# **Fletcher Stream and Wetland Mitigation Site**

## **Annual Monitoring Report**

Subject: Re: Draft MY4 Monitoring Report  
Fletcher Stream and Wetland Site, Henderson County  
French Broad River CU 06010105  
DMS Project ID No. 100004 / DEQ Contract #006997

EWS received and reviewed the comments for the Fletcher Creek Site Draft MY4 Monitoring Report from DMS on January 11, 2024. The following are the responses to those comments/questions (**IN RED**):

Current Condition Plan View  
Fletcher Mitigation Site  
Monitoring Year 4  
Henderson County, NC  
NCDMS Contract No.: 006997  
NCDMS Project No.: 100004  
December 2023  
Sheet 4 of 12

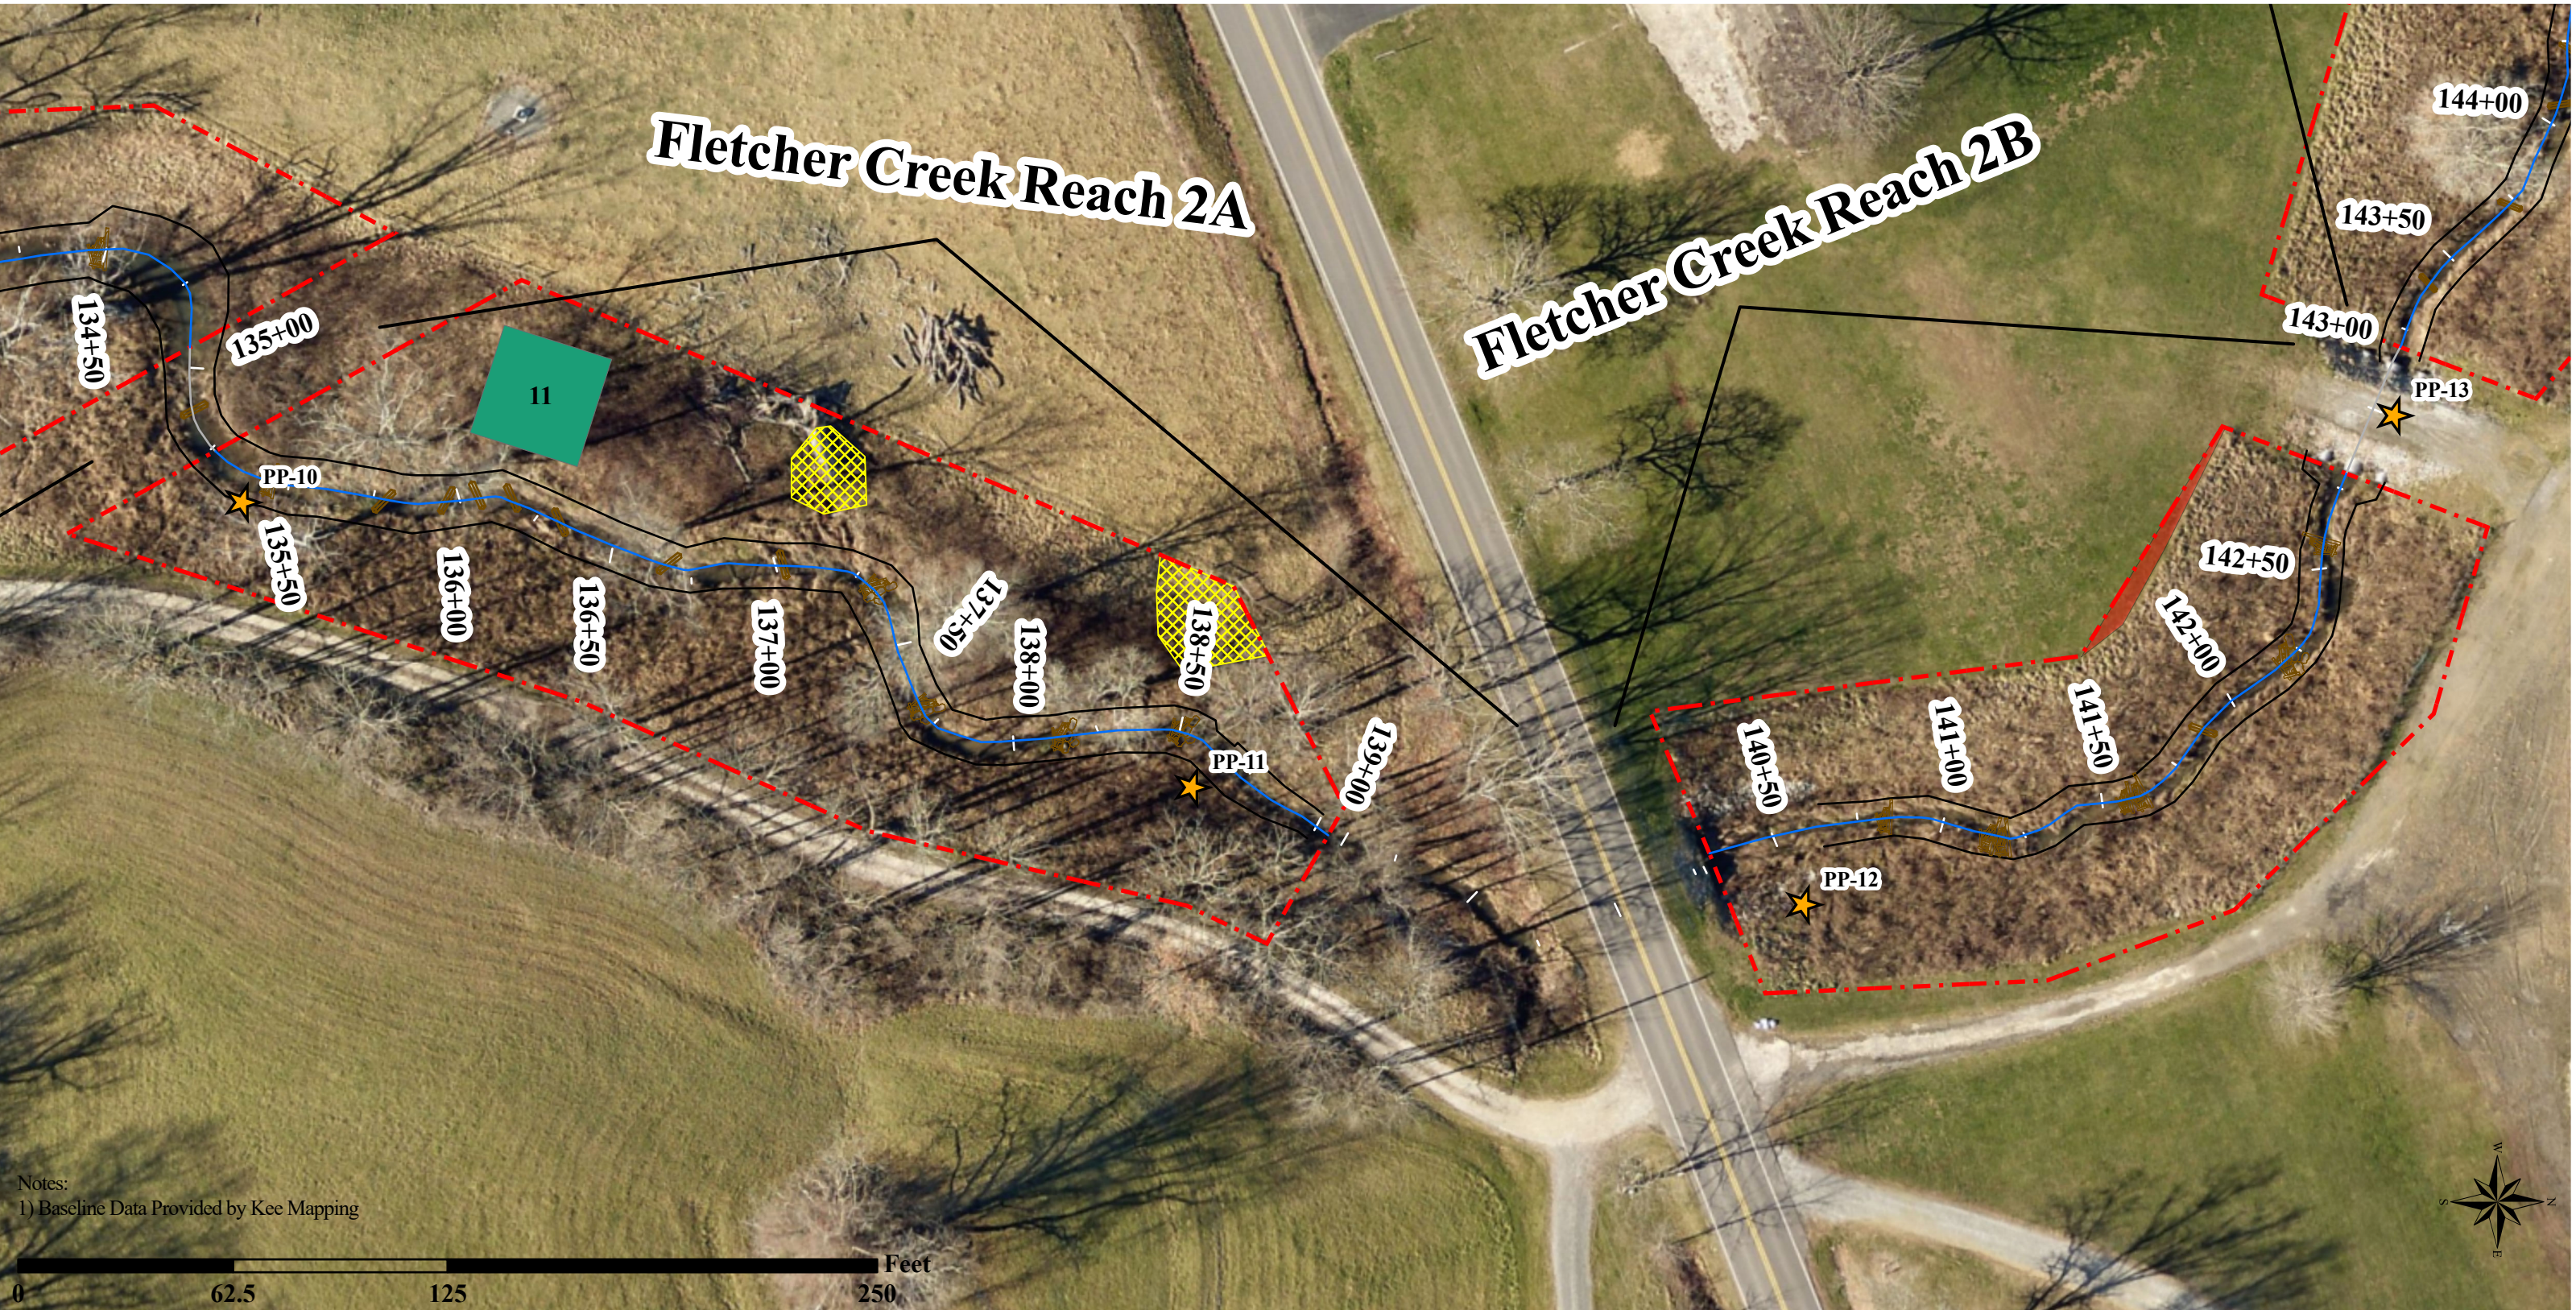
- Bank erosion was noted in the prior year’s monitoring report (MY3) near Fletcher Creek STA 142+50; however this area is not noted on the CCPV (Sheet #4) or included in the photo section in the MY4 report. Was this area repaired or has it healed over? If not please provide an update on its condition, along with any applicable supportive data/photos. **The area has healed over.**
